DOCKET ITEM #9

Master Plan Amendment #2018-0007

CDD Concept Plan #2016-0003

Greenhill / West Alexandria CDD –

Figure 1: Preliminary CDD Concept Plan

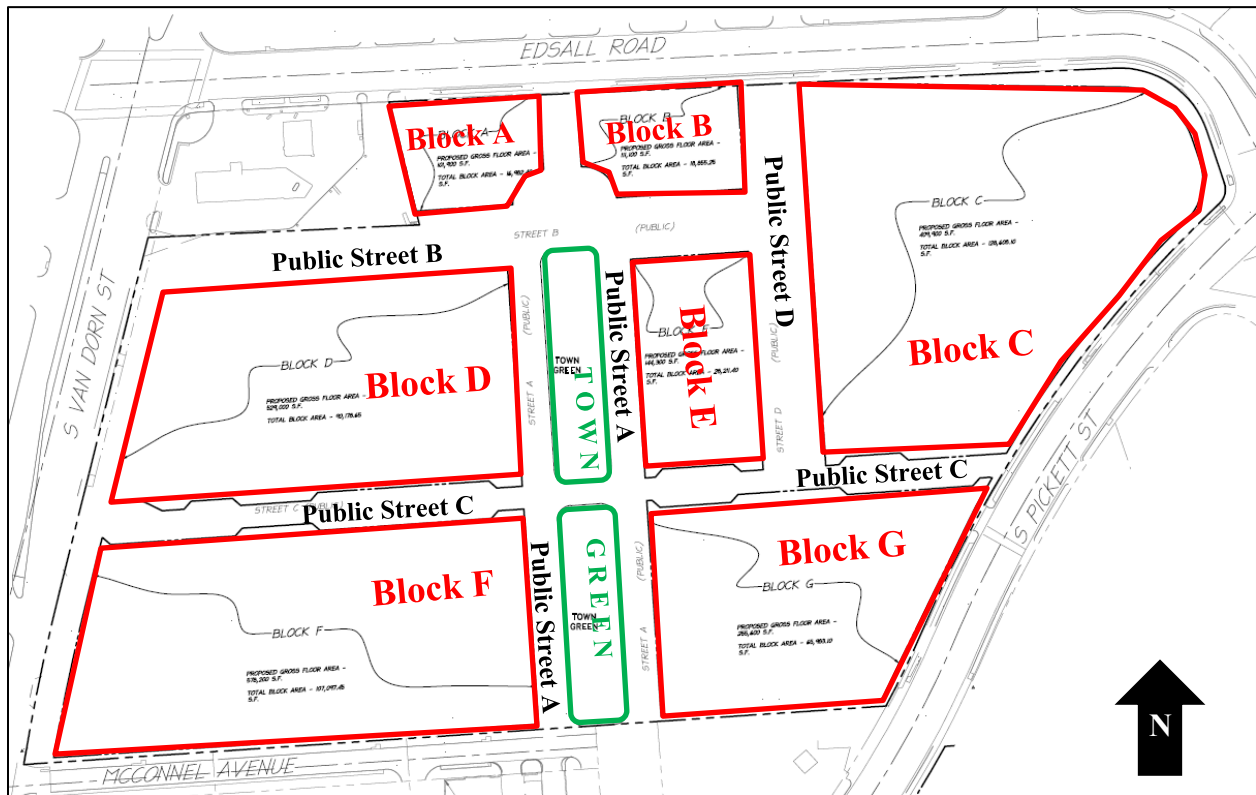
Although supportive of the CDD Concept Plan, staff has also included recommended conditions in this report that request certain revisions to the proposal. The requested revisions range from those technical or modest refinements to the plan, such as the provision of a grocery use as recommended in the Landmark-Van Dorn Corridor Plan, to more substantial revisions. The four substantial revisions are:

The requested an eastward shift of the major north-south street (Public Street A) by approximately 35 feet would better align its southern terminus with the potential northern terminus of the multimodal bridge. In the applicant's preliminary plan, Public Street A was located far enough to the west that any future connector road to the south would have difficulty clearing the northeastern corner of the Modera Tempo building. Although a connection from Public Street A to South Pickett Street and the potential multimodal bridge would involve the use of private property not included within the CDD Concept Plan area, staff nonetheless believes it is important to not preclude such a connection in the future. The Corridor Plan envisioned the street in question potentially connecting to South Pickett Street and the potential multimodal bridge landing in this location provided an additional rationale for such a request.

Staff requested that the applicant provide a full public right-of-way of 78 feet for Public Street C as recommended in the Corridor Plan rather than the originally-proposed 24 to 44-foot widths, which would have included only the distance between the street's northern curb to its southern curb. In the revised right-of-way for Public Street C, the majority of the streetscape would be located on public property as required for the majority of new development projects in the City. The applicant has agreed to both the realignment of Public Street A and the standard right-of-way width for Public Street C and has incorporated both changes into a new exhibit included as Graphic #2 in Section VIII of this report. Staff has included condition language (Conditions #14 and #16) to memorialize this agreement and to incorporate the changes into a revised CDD Concept Plan.

Exhibit A - Roadway Connection Not Preferred

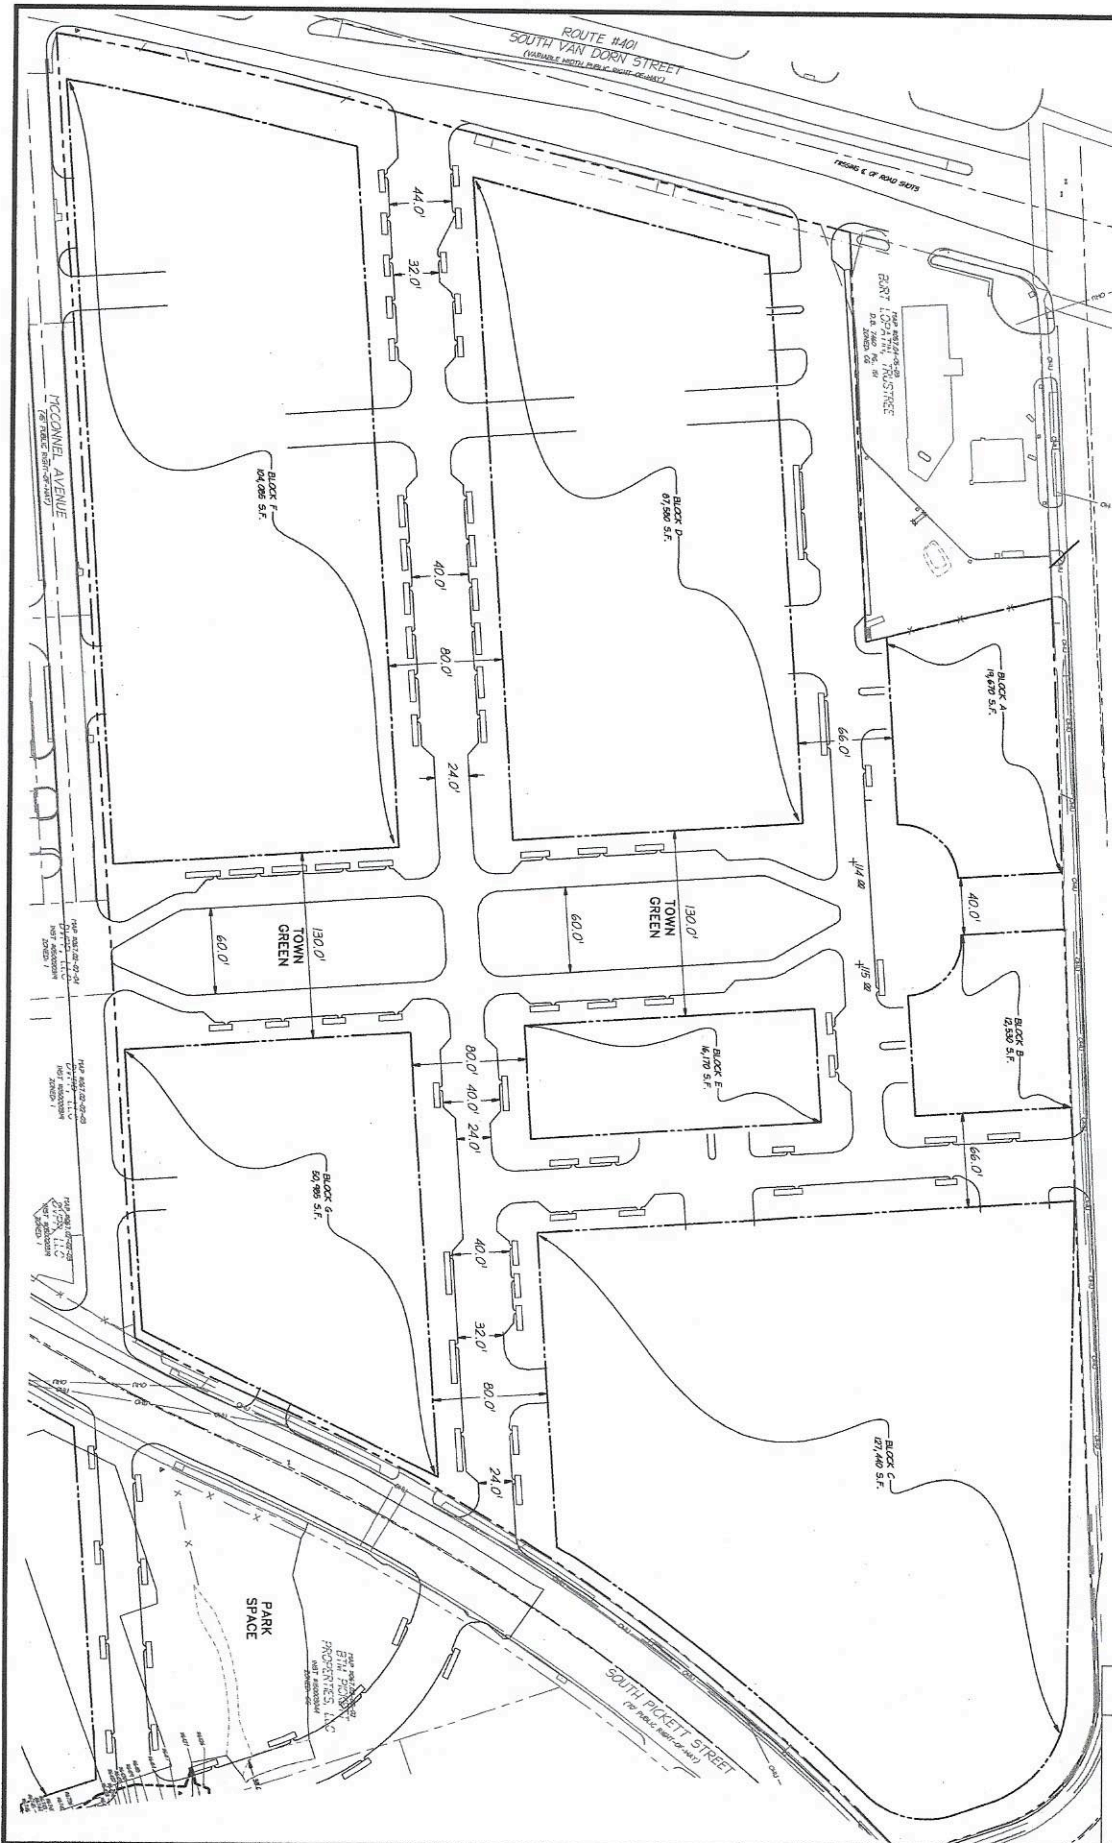
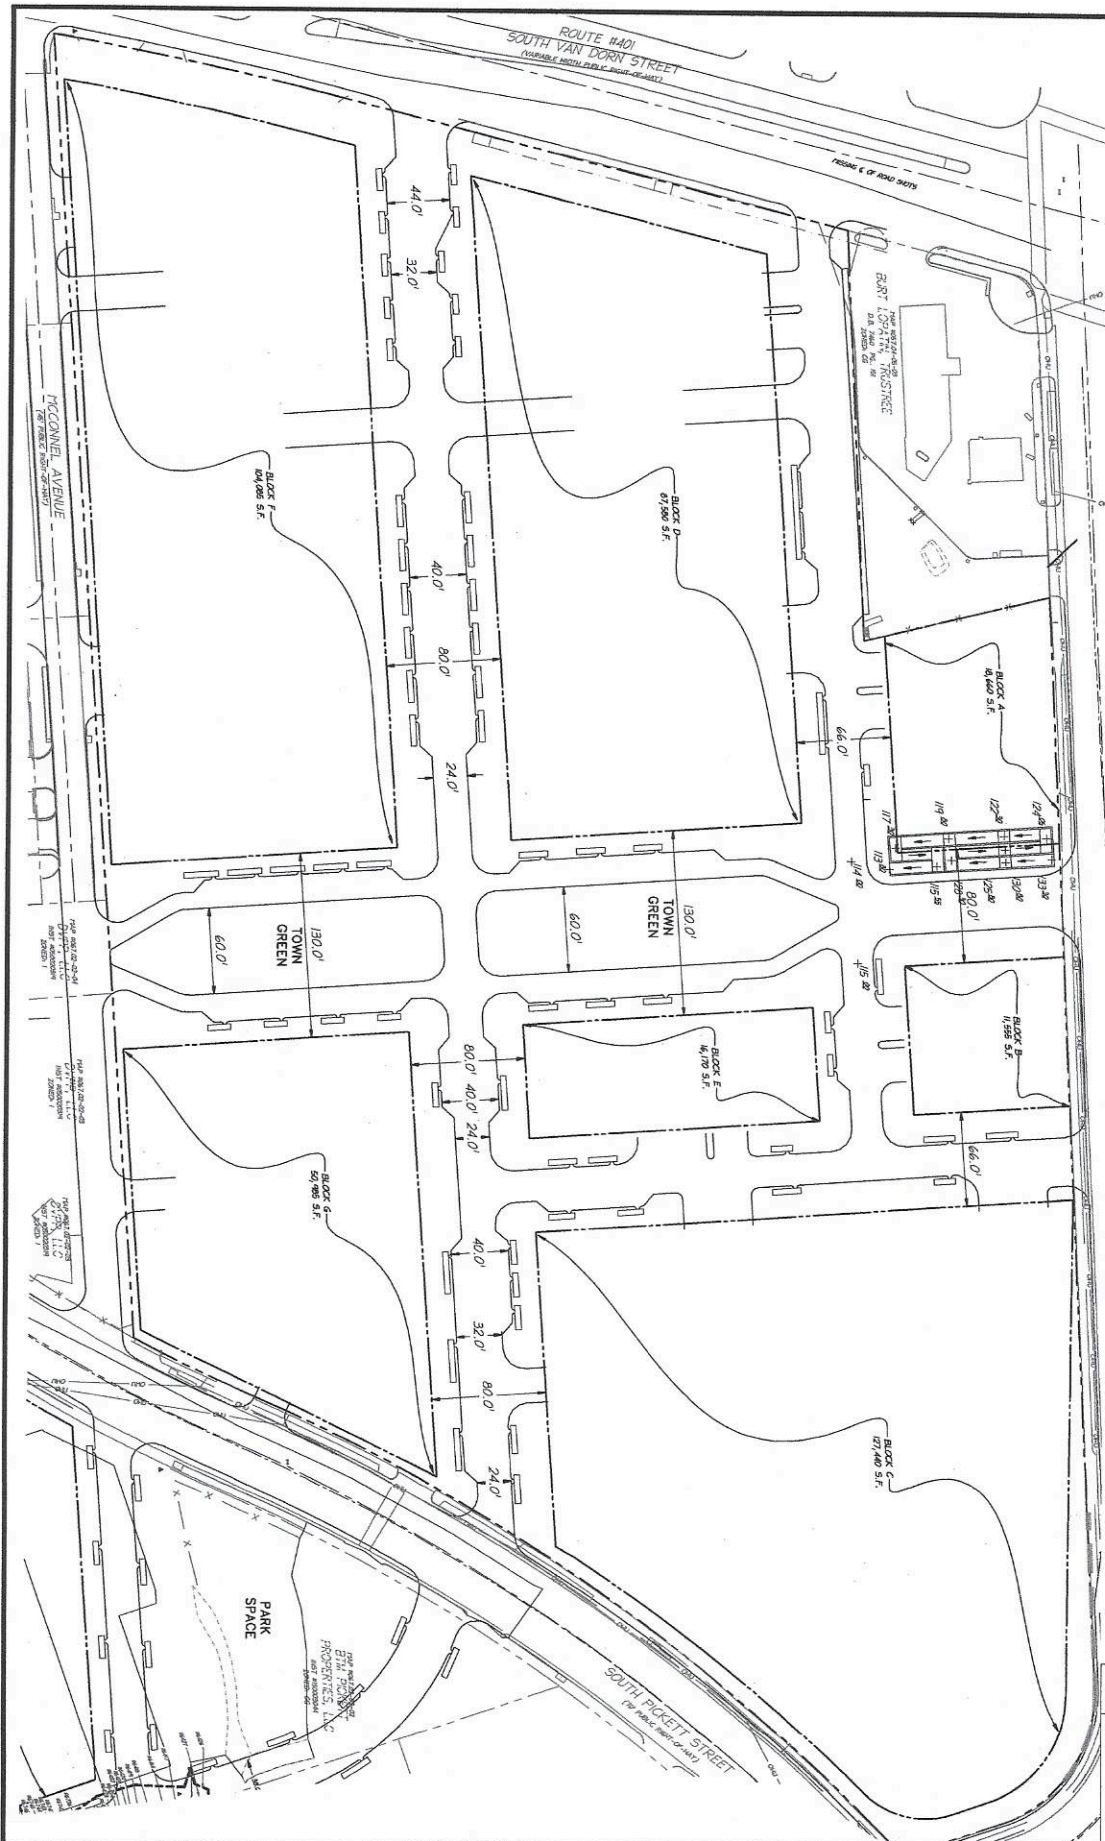
We continue to disagree that it is advisable from an engineering perspective to provide a vehicular connection to Edsall road via Public Street A (the major north-south street). As a result, we did not include the following change: "The reconfiguration of the area between Blocks A and B, now listed as the "Spanish Steps," to allow for a vehicular connection to Edsall Road. The right-of-way width to depict between Blocks A and B would be 80 feet." As you can see on Exhibit 1, attached hereto, we believe the vehicular connection is not advisable for several reasons. First and foremost, the change in grades between Edsall and the new Public Street "B" would cause the slope of that portion of the road to be at 14%, a slope not recommended on a regular basis by the Department of Transportation and Environmental Services. Vehicles coming up that 14% slope to the new intersection would be at a disadvantage moving into the

Finally, staff has recommended in Condition #43 that the applicant provide engineering plans in the future for City staff to determine the feasibility of requiring a vehicular connection to Edsall Road, as part of the public right-of-way for Public Street A, between Blocks A and B on the north-central portion of the CDD Concept Plan area. Planning & Zoning and Transportation & Environmental Services staff view the provision of a north-south vehicular connection through the site as an important planning goal. The street network envisioned for the project site in the Landmark-Van Dorn Corridor Plan specifically depicts the street connecting through from South Pickett Street on the south to Edsall Road to the north. This connection is particularly important from a vehicular traffic perspective given that Public Street A has been designed to potentially align with the northern terminus of the multimodal bridge in the route currently being studied. A vehicular connection to Edsall Road would theoretically allow vehicles to travel from Eisenhower Avenue in a northern direction across the new multimodal bridge and through the project site to Edsall Road without needing to use South Van Dorn Street.
